MONA OFFSHORE WIND PROJECT

Appendix to ExQ1 Q1.5.1 Scallop Mitigation Zone

Document Reference: S_D3_25.4

Document Number: MOCNS-J3303-RPS-10340

Figure 2.1: Queen scallop grounds fished by Scottish vessels within the Mona Array Area. Grounds are categorised by WCSP into red, pink, yellow, and green zones, with the red zone being defined as the ‘Very Important’ queen scallop fishing ground.

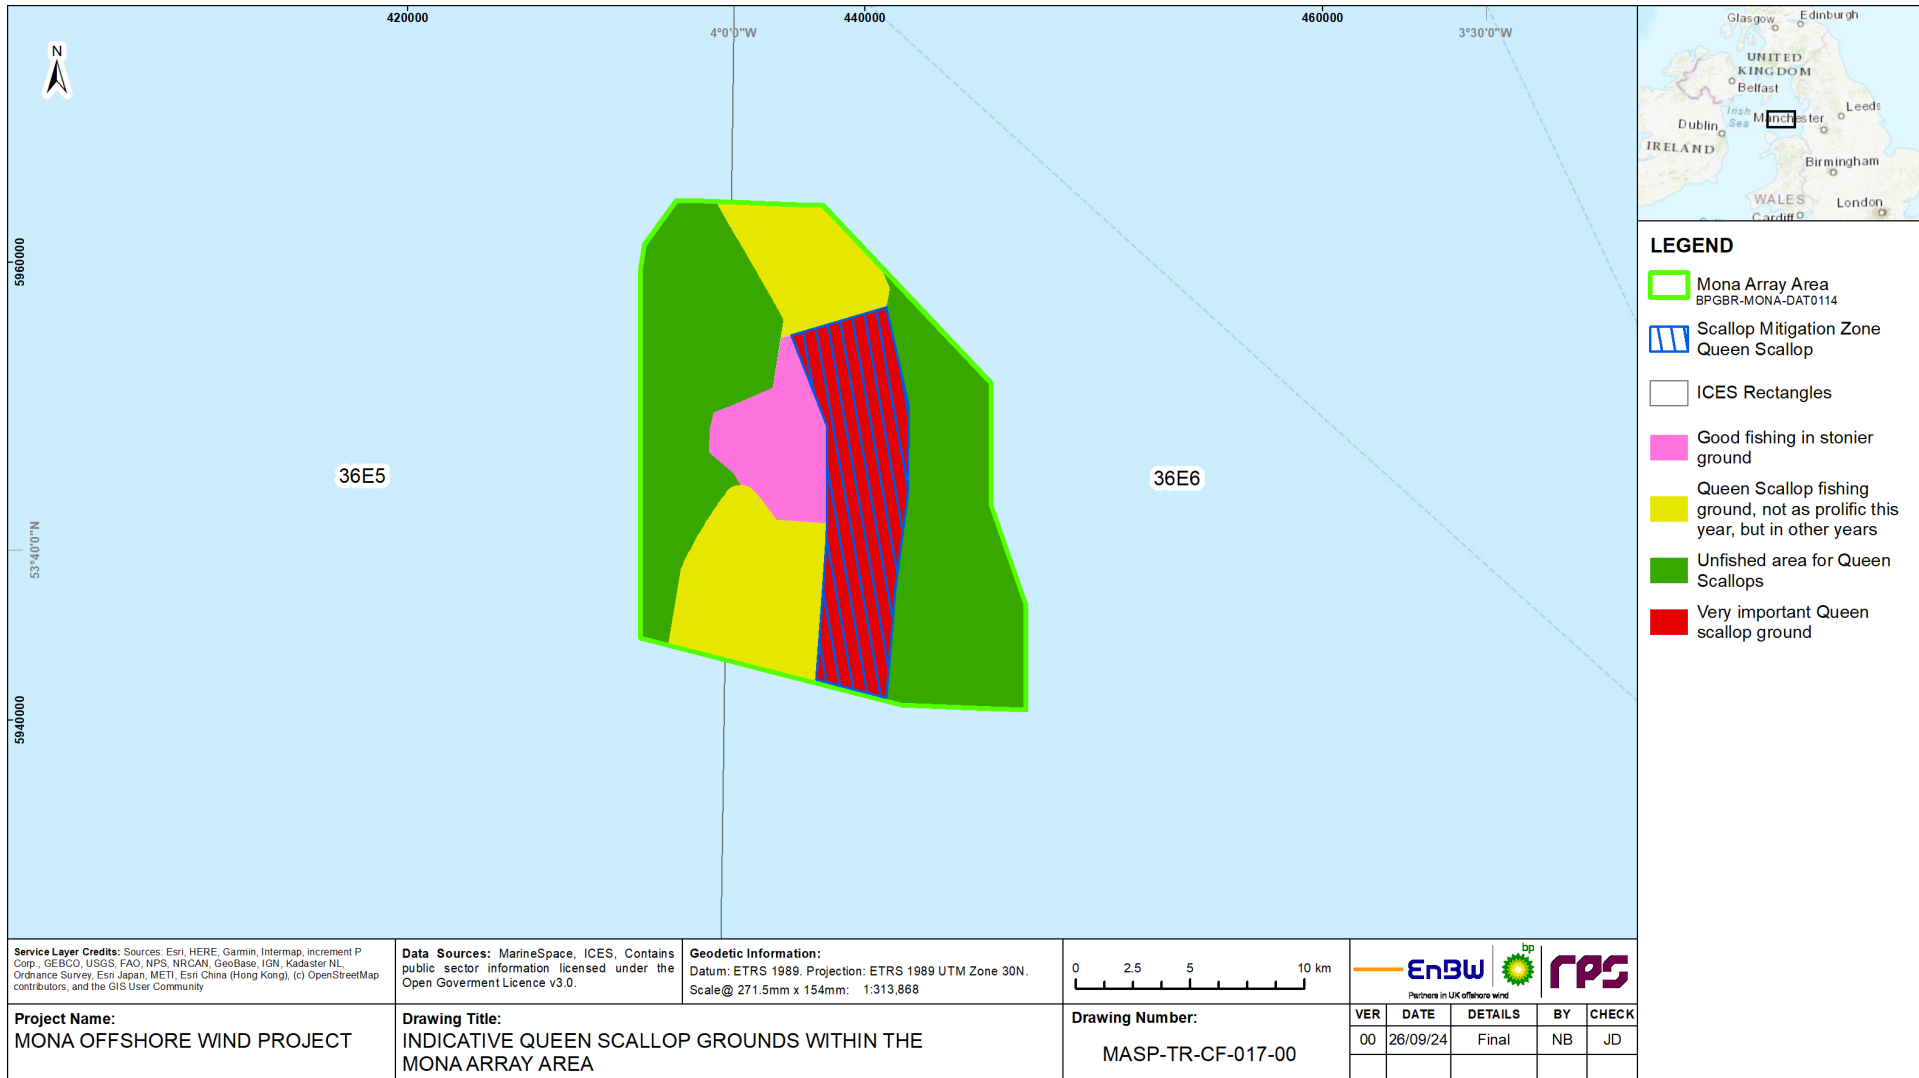
The Applicant's response to REP1-075.10 [REP2-078] states that it will commit to maintaining a Scallop Mitigation Zone (SMZ) of 57 km² by including this commitment within an update to Table 1.2 of the Outline FLCP [APP-199] at Deadline 3. As the size is much smaller in area than what the Scottish Fishermen's Federation, the Scottish Whitefish Producers Association Ltd and the West Coast Sea Products expected can the Applicant:

- i) summarise the steps it took to evaluate smaller and larger sizes and how a 57 km² SMZ area size was selected;
- ii) clarify if rock protection footprint for cables would have an impact on the size of the 57 km² SMZ; and
- iii) explain what the effects would be on the Proposed Development if it increased the SMZ by 20- 25% in area size.

- 1.2.1.3 Based on this feedback, the Mona Offshore Wind Project designed the SMZ to cover 100% of the 'Very Important' ground (Figure 2.1), which covers 37% of the wider queen scallop grounds. The term 'core queen scallop ground' was adopted by the Applicant to describe the area covered by the SMZ and to and recognise that it covered the 'Very Important' (or 'core') ground rather than all of the grounds.
